# Aesthetic Assessment and Recommendations for the Proposed VELCO Lamoille County Project Transmission Line and Substation Upgrades

Docket No. 7032, VELCO Lamoille County Project

Submitted to:  
State of Vermont  
Department of Public Service  
Montpelier, VT

Submitted by:  
LandWorks  
Middlebury, VT

**Approx.  
Mile 7.3**

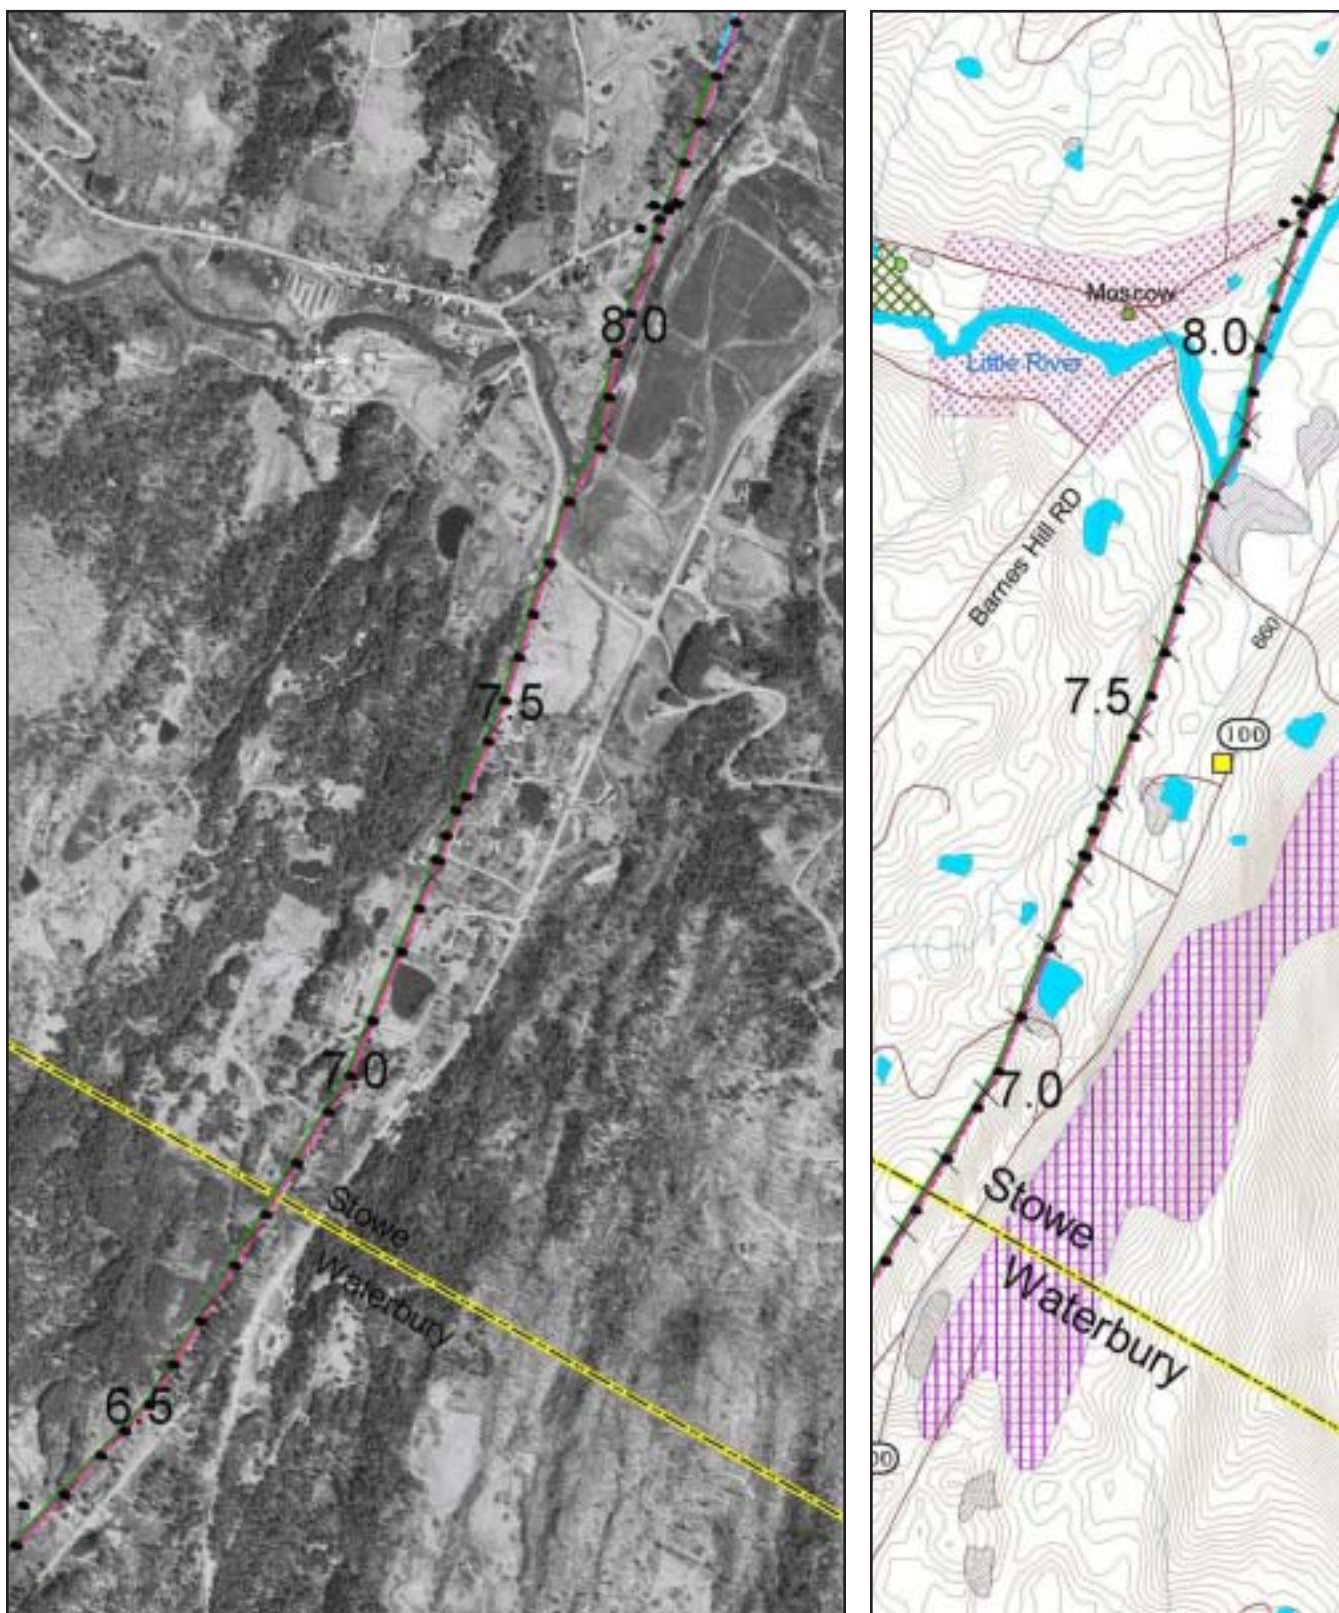
View up corridor from Marshall Rd. Proposed line will change the look and overall character of the neighborhood with its visual impact to the road and homes.

**Approx.  
Mile 7.9  
- 8.1**

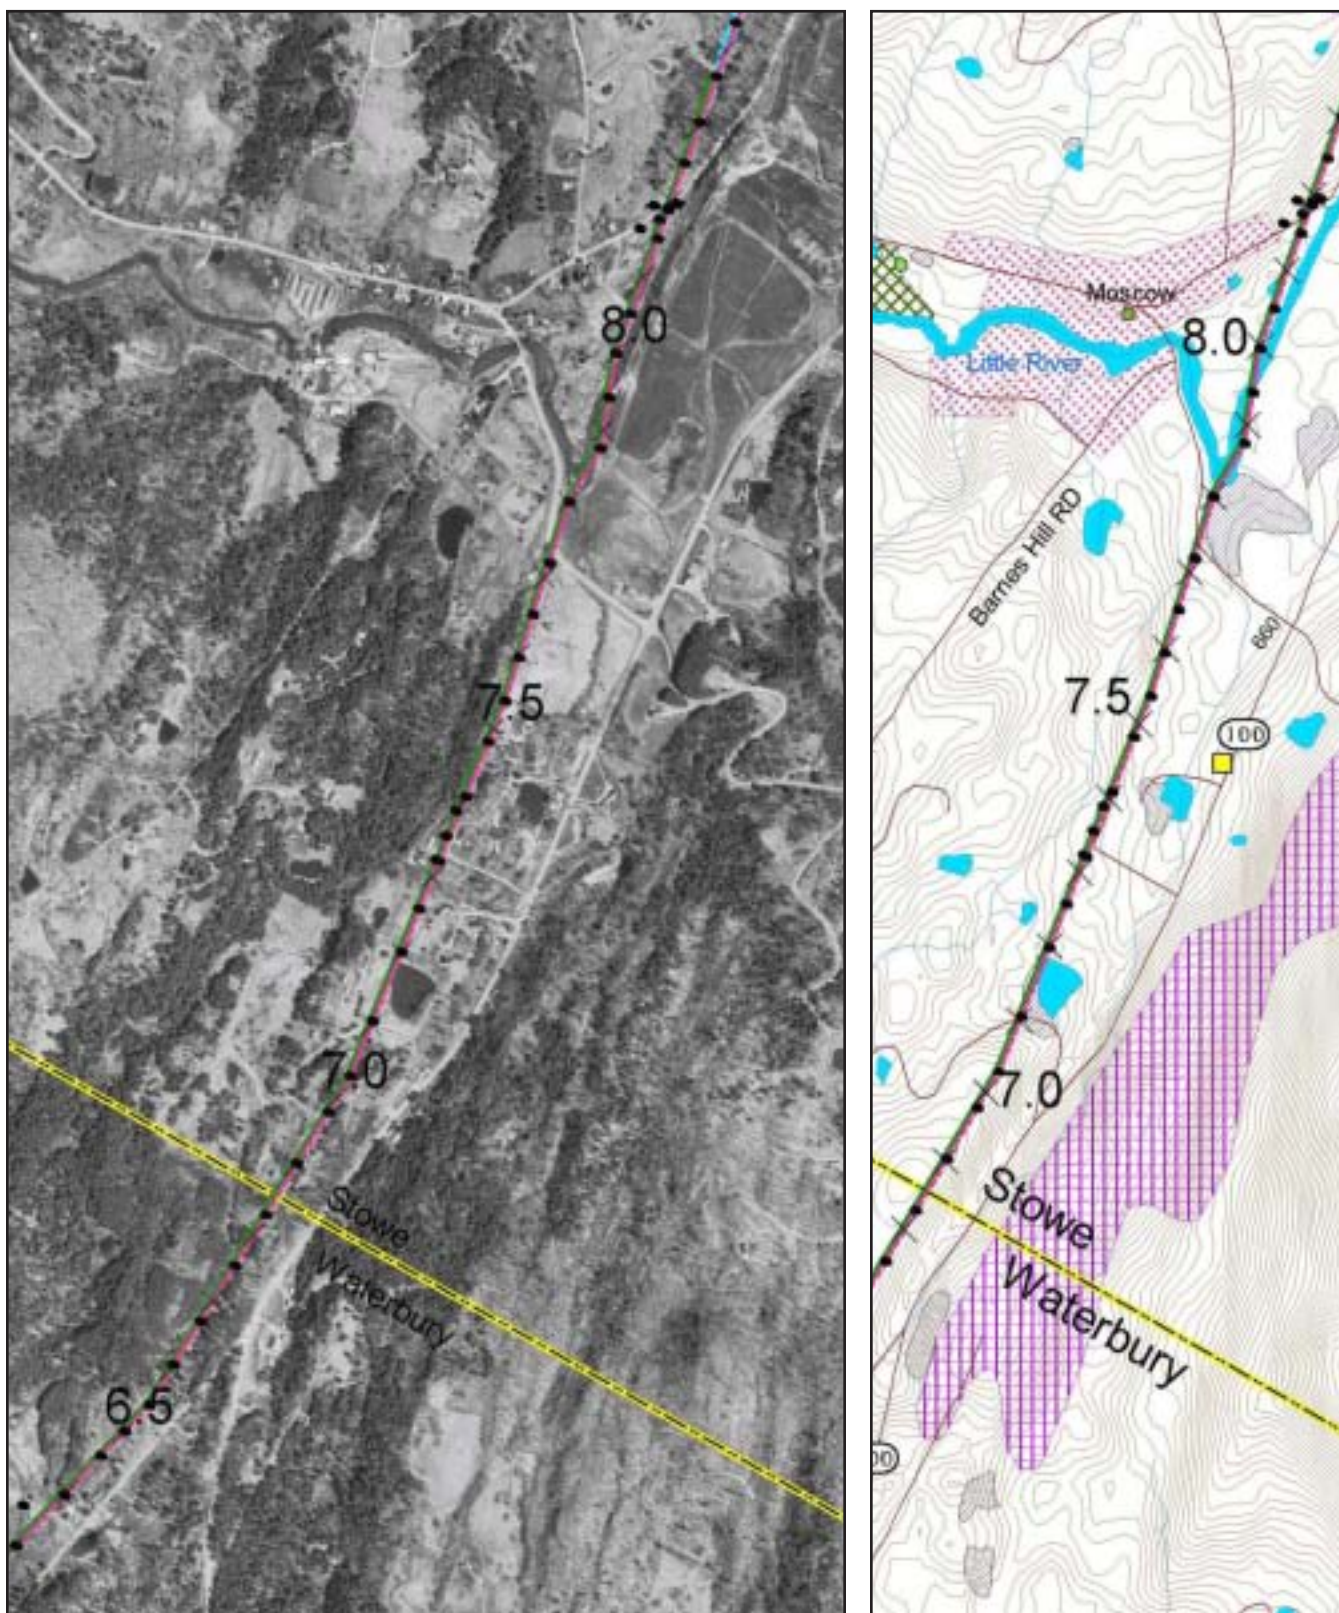
Vegetation in foreground helps to assimilate existing corridor. Critical to retain vegetation and add to it.
